# Access Compliance Report

## Public Rights-of-Way

### (Curb Ramps)

Intersection ID: 8380	Main Street: CENTRE_ST	Cross Street: TENNESSEE_AV	Location:	N
ADA ID: EDE964EE0787	Ramp Type: Perp	Initial Pass/Fail: Pass	Overall Compliance: No	Severity Score: 0.25
Codes/Mitigation Info/Possible Solution		Field Measurements/Component Compliance

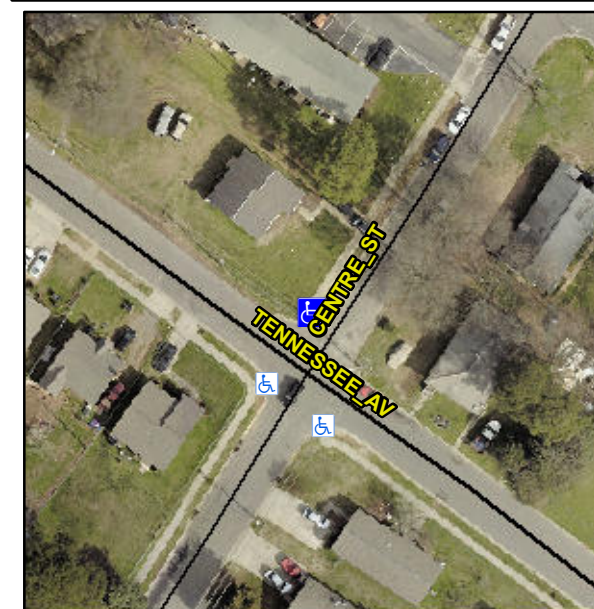
**Not Found, R304.5.3, R305.2**

Compliance	Description	Data	Compliance	Description	Data
N/A	Ramp Length (in)	48.0	Yes	Ramp Slope (%)	5.9
Yes	Ramp Width (in)	48.0	No	Ramp XSlope (%)	3.4
N/A	Flare Type LT	Sloped	N/A	Flare Type RT	N/A
N/A	Flare Slope LT (%)	5.4	Yes	Flare Slope RT (%)	0.9
N/A	Flare Traversable LT?	Yes	N/A	Flare Traversable RT?	Yes
Yes	Landing Length (in)	60.0	Yes	DWS Provided?	Yes
Yes	Landing Width (in)	54.0	Yes	DWS Contrast?	Yes
Yes	Landing Slope (%)	1.4	Yes	DWS Length (in)	24.0
No	Landing X Slope (%)	2.8	Yes	DWS Full Width?	Yes
N/A	Landing Curb? (Y/N)	No	No	DWS Offset (in)	3.0
N/A	Shared Landing?	No			
Yes	Gutter Ponding?	No	Yes	Gutter Slope (%)	1.2
Yes	Gutter Lip Ht (in)	0.0	No	Gutter X Slope (%)	9.0
N/A	Painted X Walk1?	No	N/A	Painted X Walk2?	N/A
	X Walk 1 Direction	To SW		X Walk 2 Direction	N/A
N/A	X Walk 1 Width (in)	N/A	N/A	X Walk 2 Width (in)	N/A
	X Walk 1 Slope (%)	2.4		X Walk 2 Slope (%)	N/A
	X Walk 1 X Slope (%)	2.6		X Walk 2 X Slope (%)	N/A

**Remove & Replace Entire Ramp.  
Remove & Replace Gutter.**
